<b>DOCKETED</b>	
<b>Docket Number:</b>	23-OPT-01
<b>Project Title:</b>	Fountain Wind Project
<b>TN #:</b>	248330-4
<b>Document Title:</b>	Project Revisions Memo Feb 2021
<b>Description:</b>	N/A
<b>Filer:</b>	Caitlin Barns
<b>Organization:</b>	Stantec Consulting Services, Inc.
<b>Submitter Role:</b>	Applicant Consultant
<b>Submission Date:</b>	1/5/2023 10:09:40 AM
<b>Docketed Date:</b>	1/5/2023

To:	Lio Salazar	From:	Caitlin Barns
	Shasta County Planning		Portland, Oregon
File:	Fountain Wind Project	Date:	February 12, 2021

**Reference: Analyses of Refinements to the Project Description Since Circulation of the Draft Environmental Impact Report**

Title: **Fiber Optic Runs**

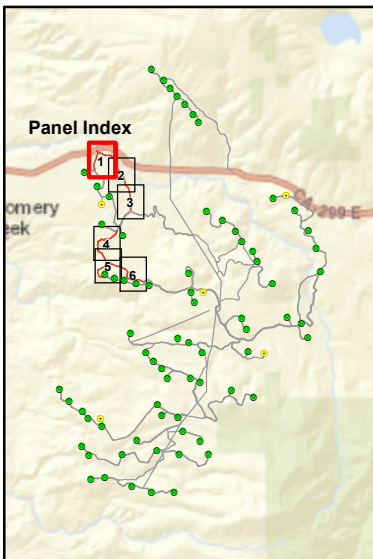
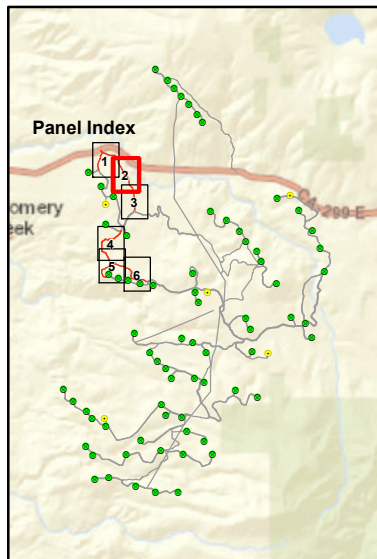
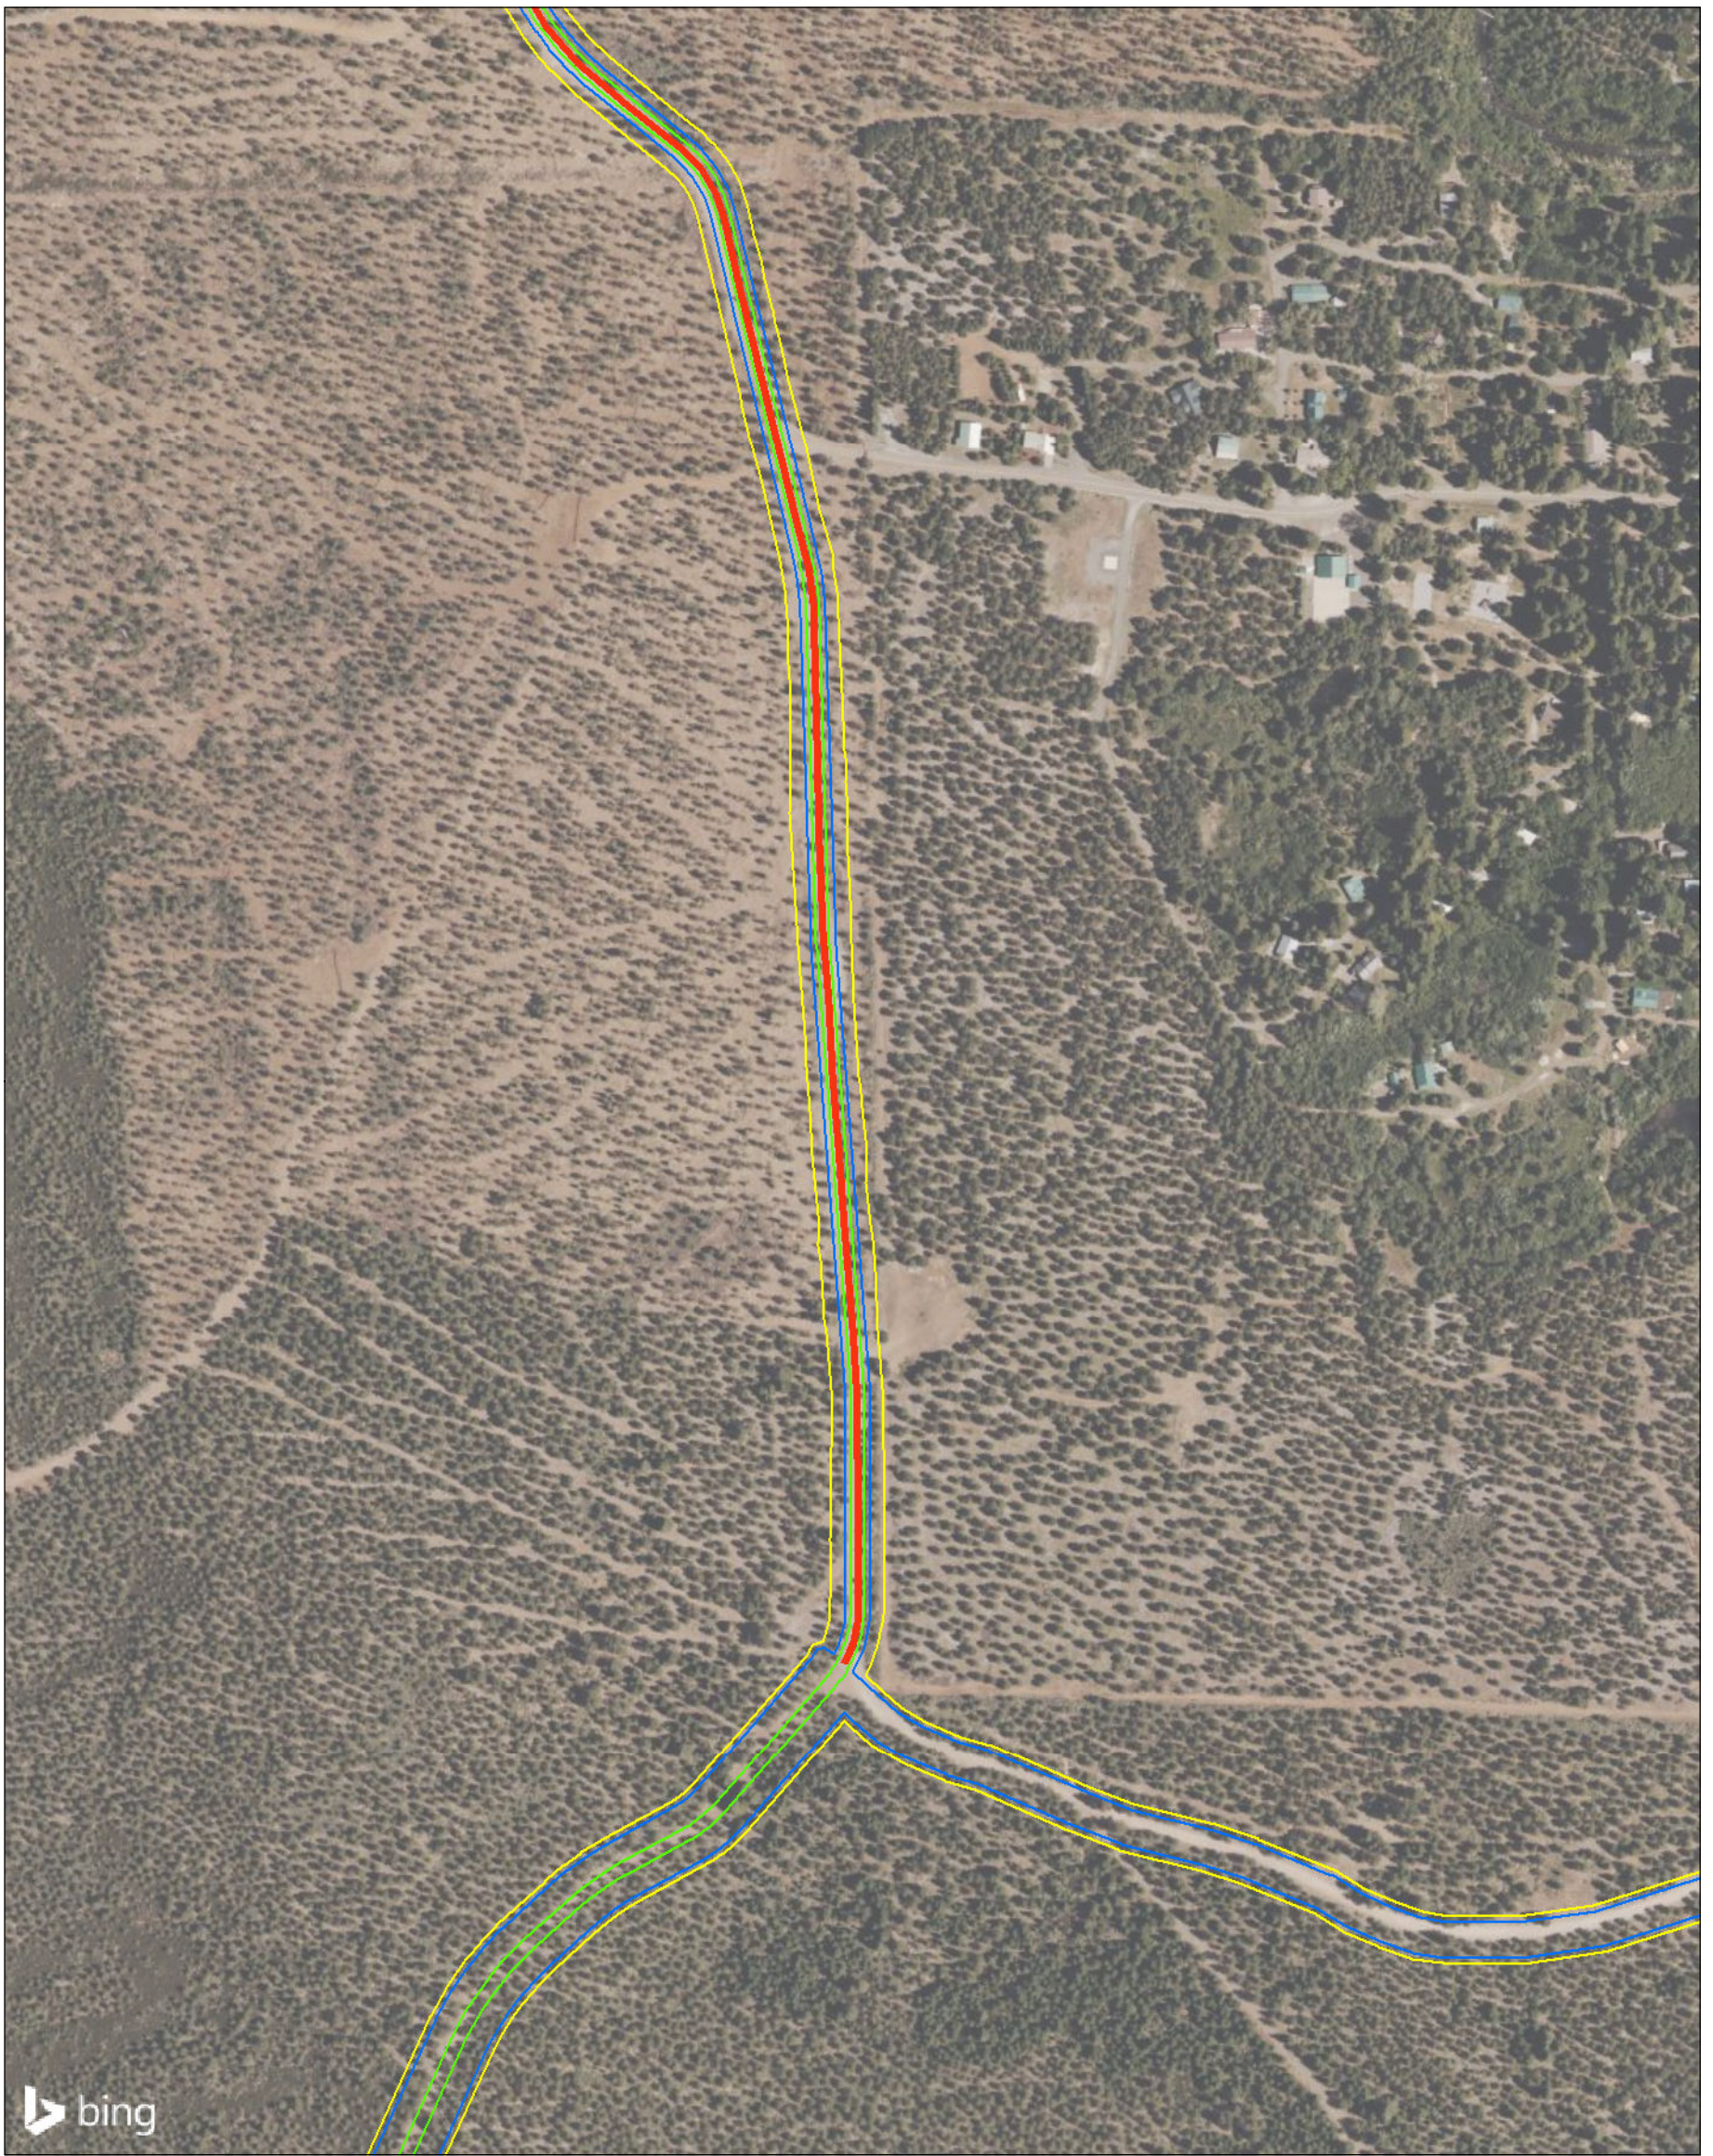
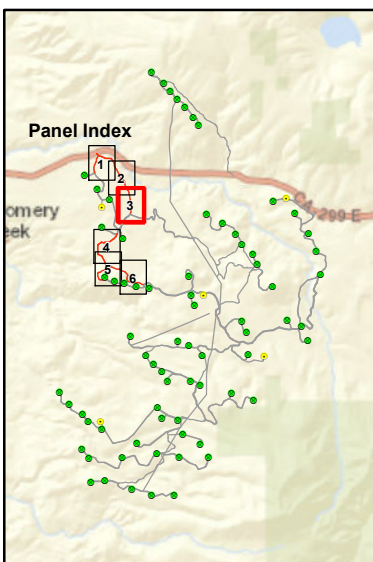
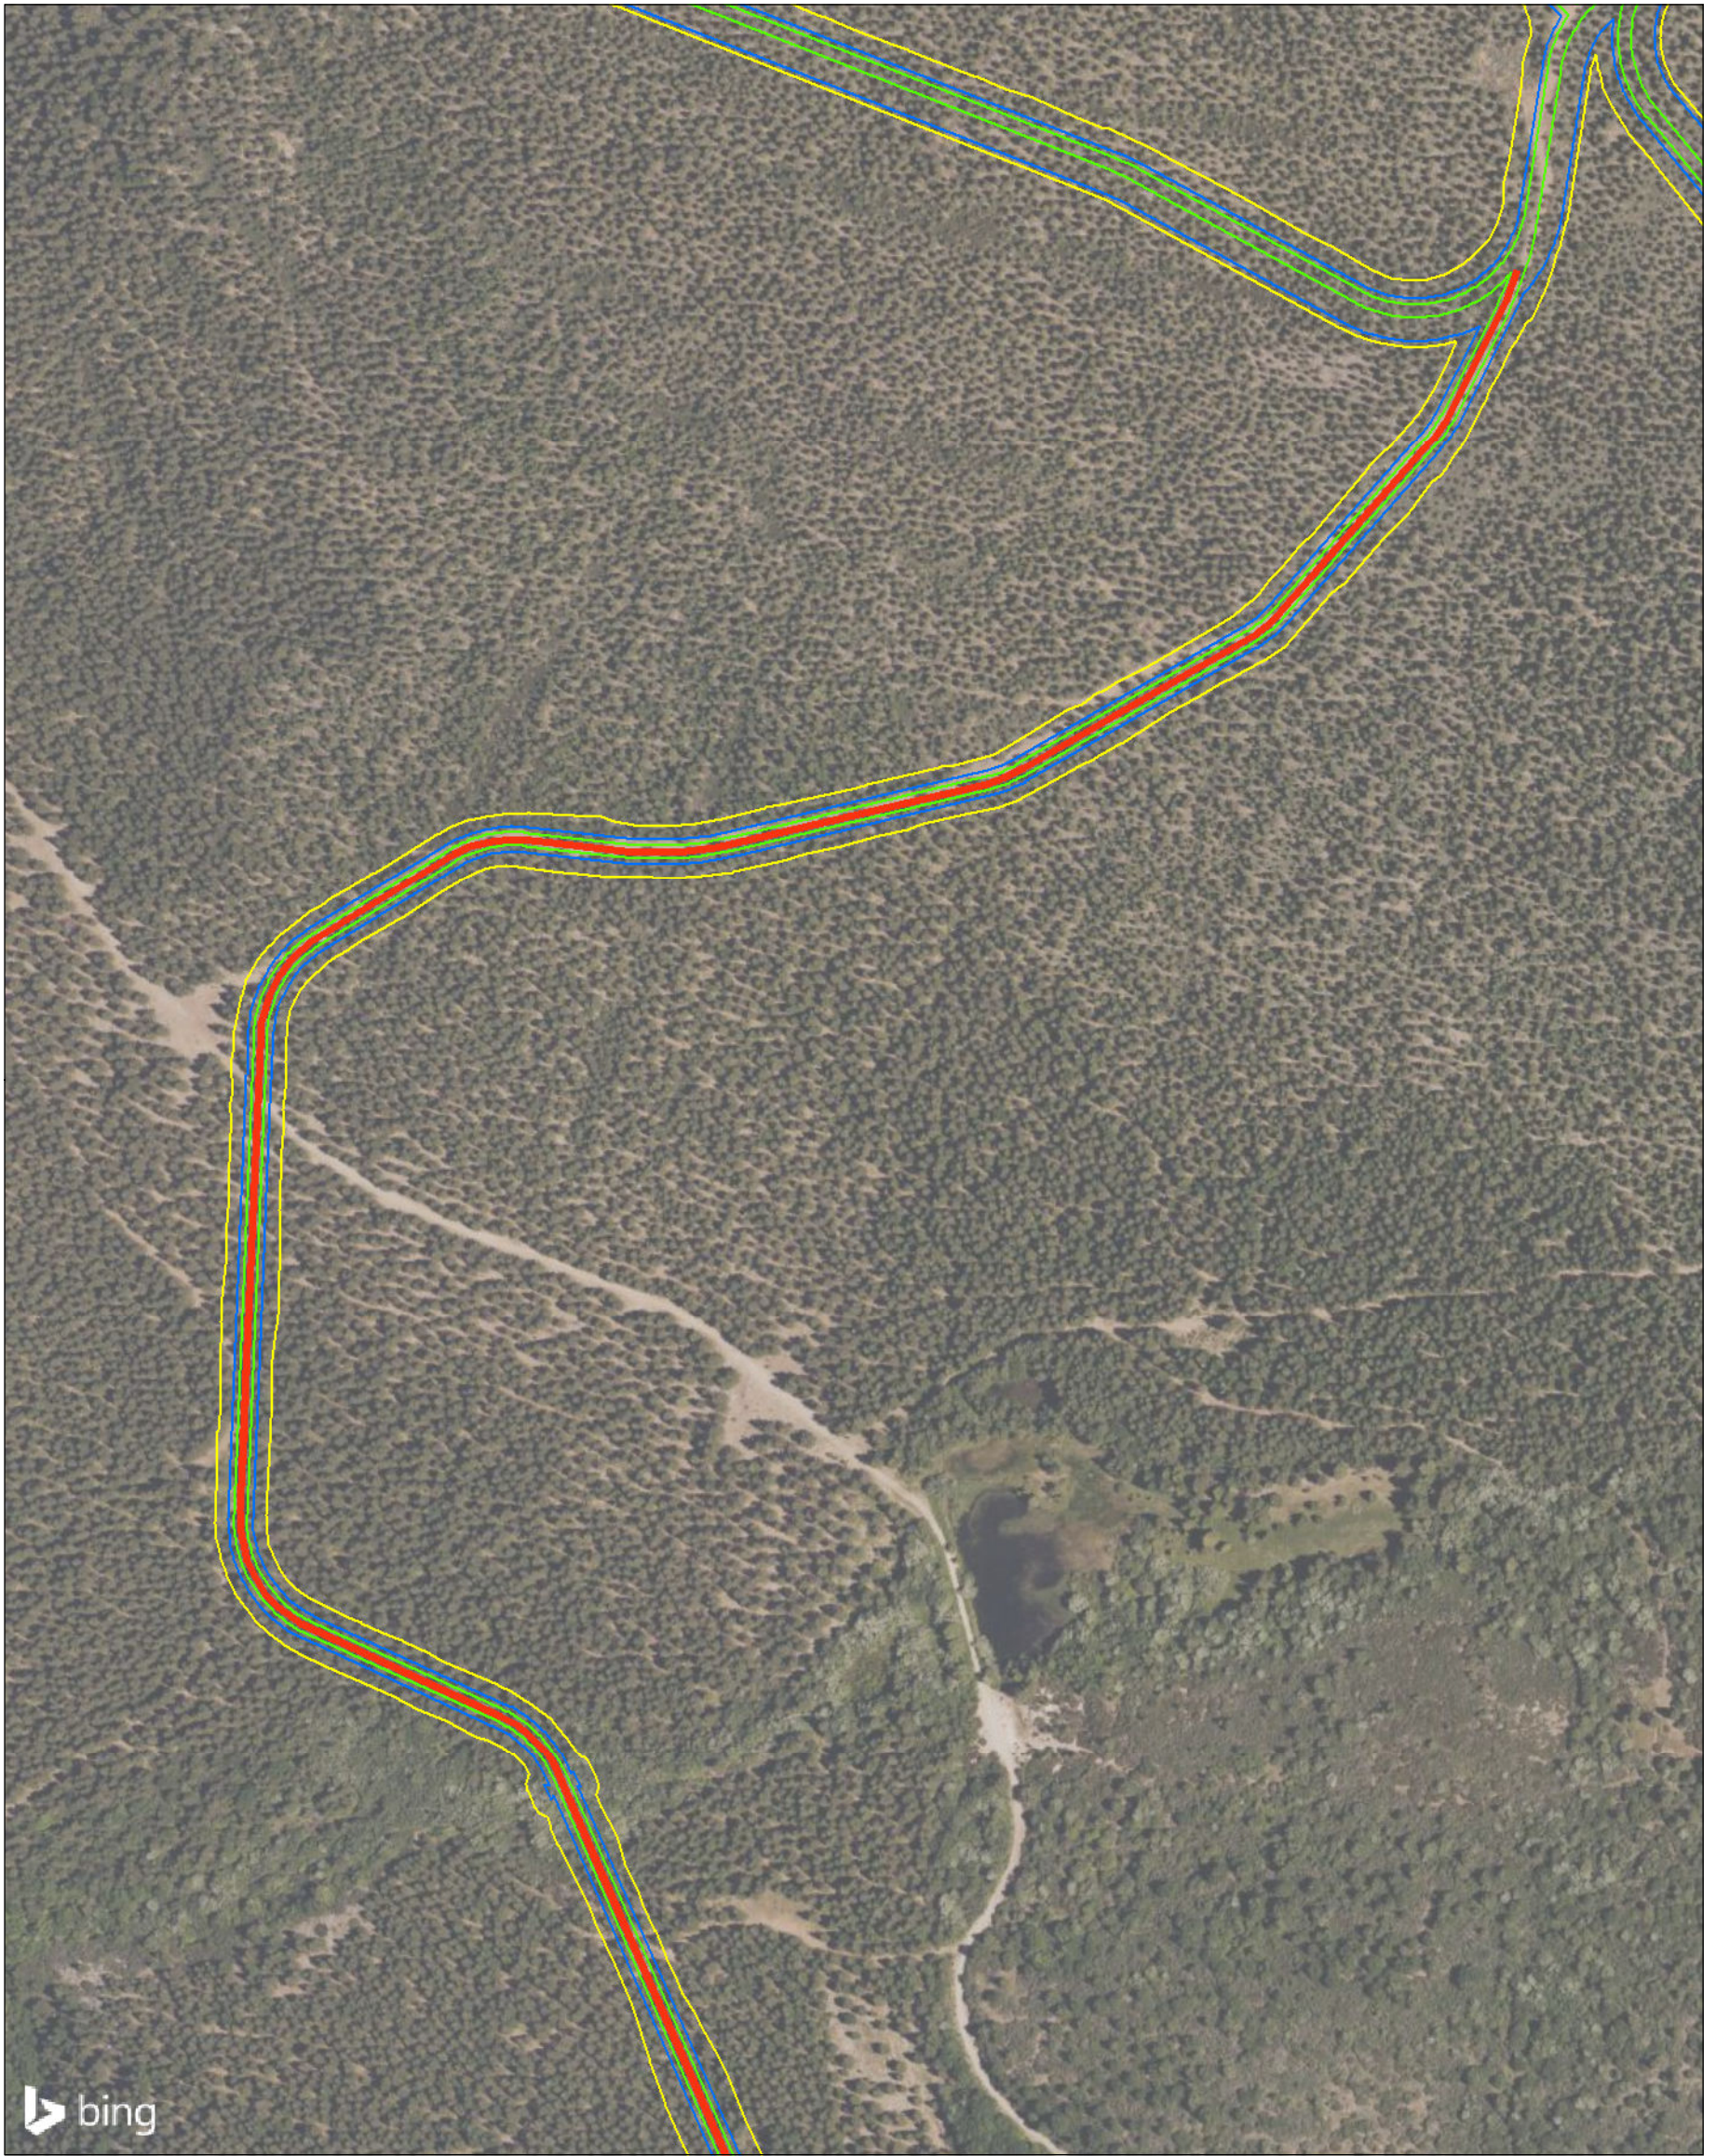
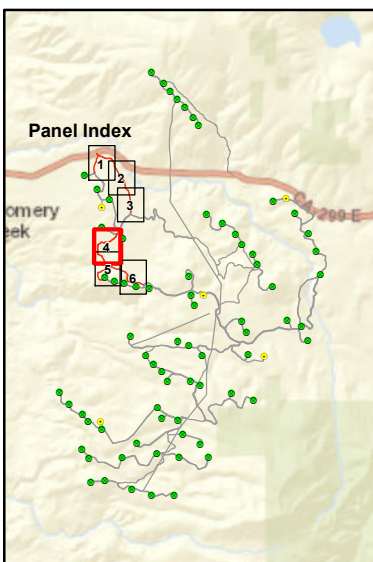
- **Clarification regarding fiber optic cable installation.** Chapter 2, Description of Project and Alternatives, in the Draft EIR states that the Project would include installation of a communication system within the same footprint as the electrical collection system. “The communication system consists of fiber optic communication cabling for the Supervisory Control and Data Acquisition (SCADA) system, which provides communication capabilities between turbine locations, substation, and operations and maintenance facilities. Most of the collector system would be located underground and adjacent to onsite access roads” (DEIR Section 2.4.2). To clarify this description, fiber optic cabling would be installed within the footprint of the electrical collection system as well as within approximately 4.5 miles of existing access roads in the northeastern portion of the Project Site. The approximately 4.5 miles of fiber optic cabling co-located with the existing roads would connect the proposed electrical system to the operations and maintenance facility, and to the existing fiber optic system located off of SR 299. See Figure 2.
